ADDENDUM #1
HVAC Improvements – Building A
Bear River High School
11130 Magnolia Road, Grass Valley, CA
Nevada Joint Union High School District

Delta 1 Revisions:

A-6

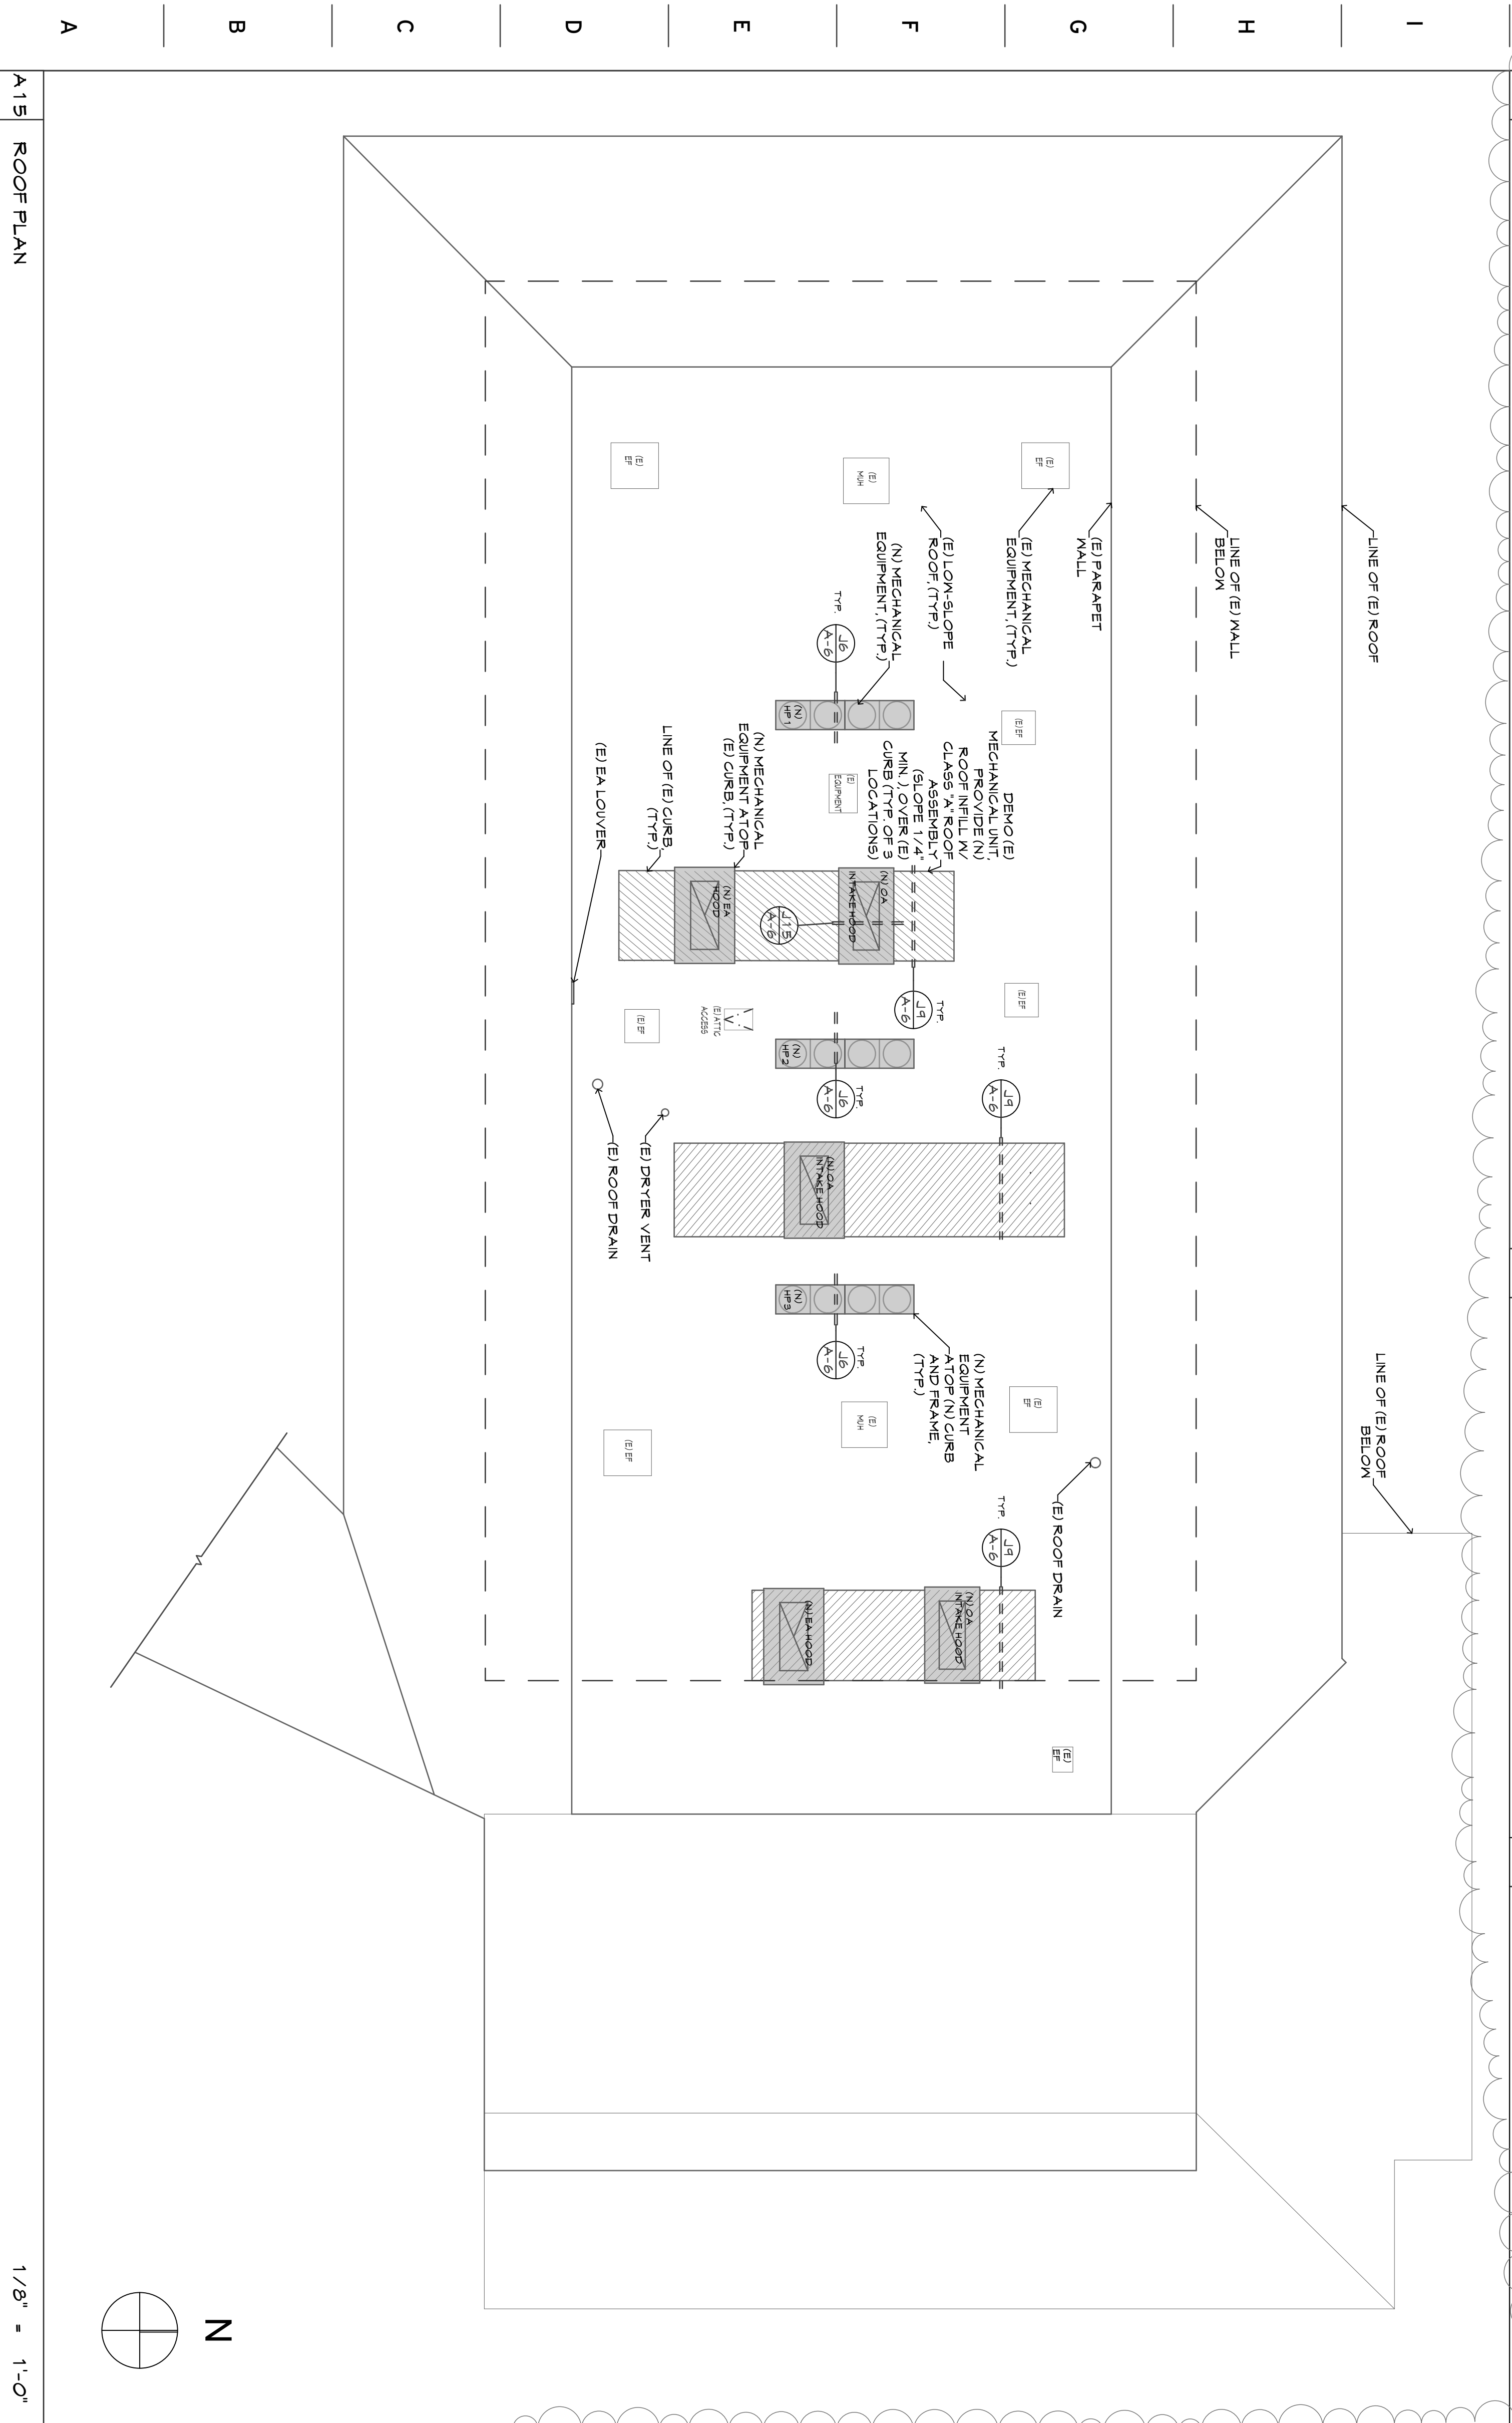
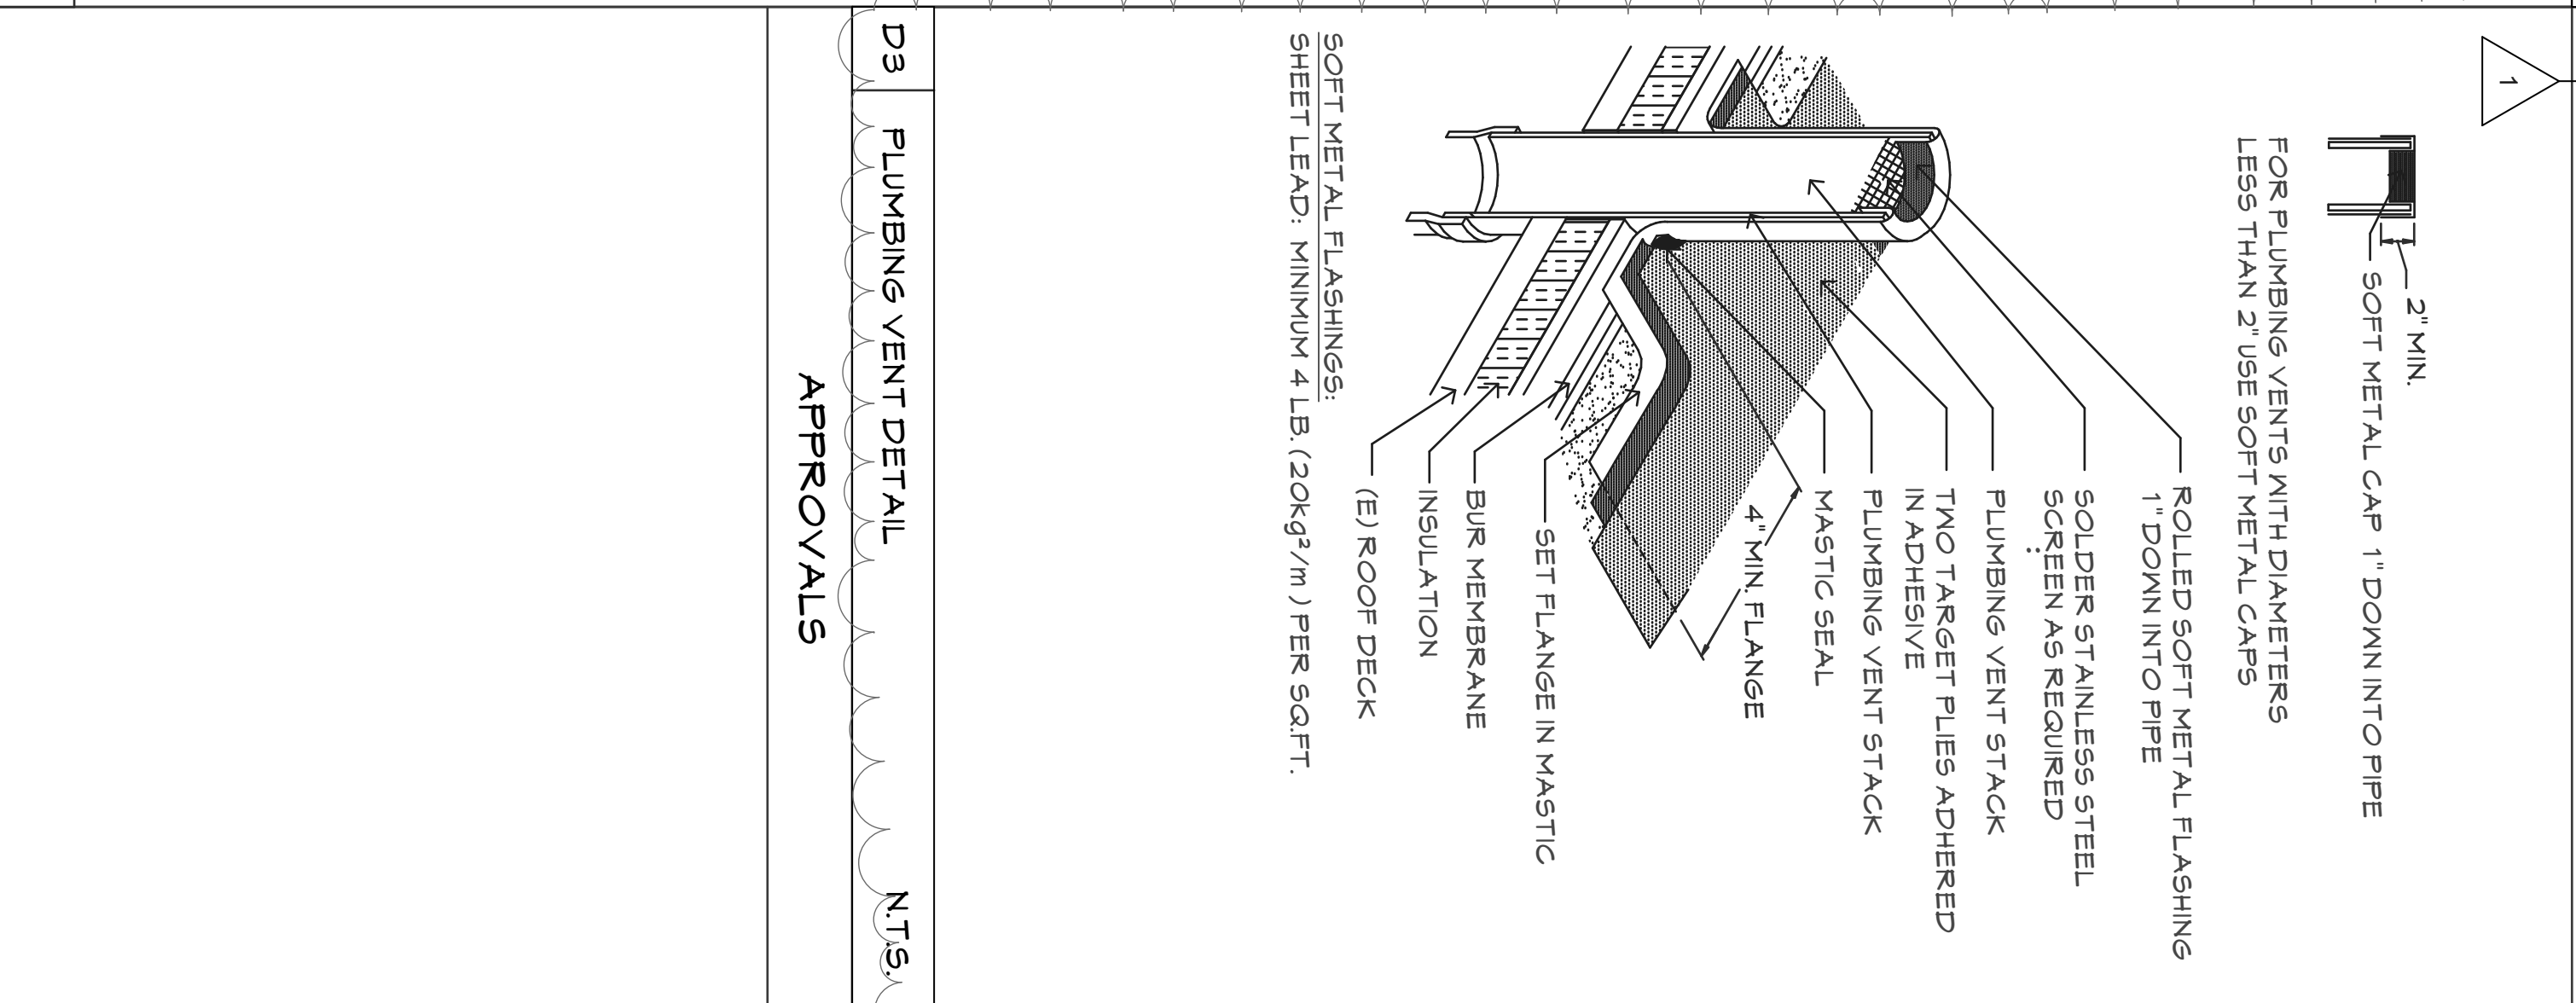
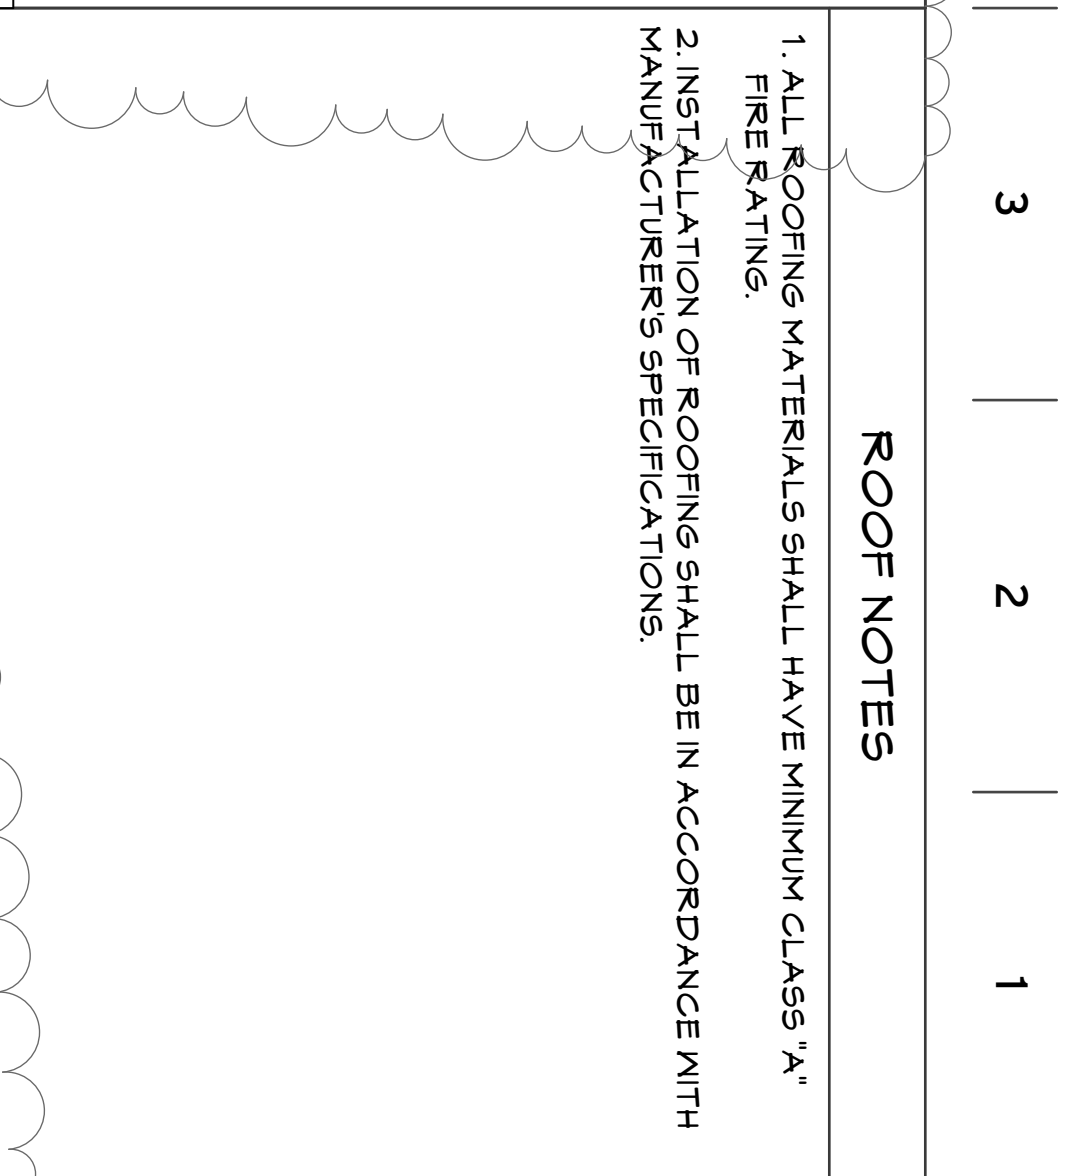
1. Refer to revised Sheet A-6 – Roof Plan, attached. All the details have been revised to reflect the existing fluid-applied roofing.
